ENGINEERING CHANGE NOTIC NO. 03294

DWG NO. 647.9100

DWG TITLE: THRUSERTS

REASON: REVISED MATERIAL DUE TO AVAILABILITY ISSUES

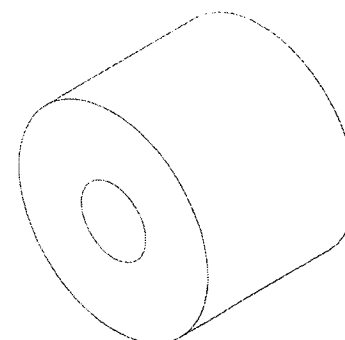
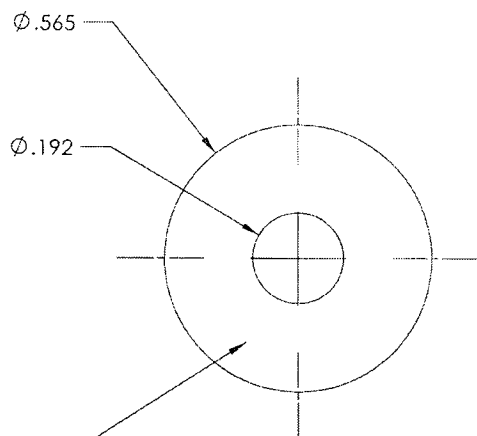
**SHEET 1, NOTES IS:**

1. MATERIAL: 303 SS IAW AMS 5640.
2. FINISH: NONE
3. DEBURR AND BREAK ALL SHARP EDGES.
4. IDENTIFY IAW MPP-120. LASER ETCH P/N AND REVISION 12 PT CENTURY GOTHIC.

1. MATERIAL: 303 SS IAW AMS 5643, 1/4H.
2. FINISH: NONE.
3. DEBURR AND BREAK ALL SHARP EDGES.
4. IDENTIFY IAW MPP-120. LASER ETCH P/N AND REVISION 12 PT. CENTURY GOTHIC.
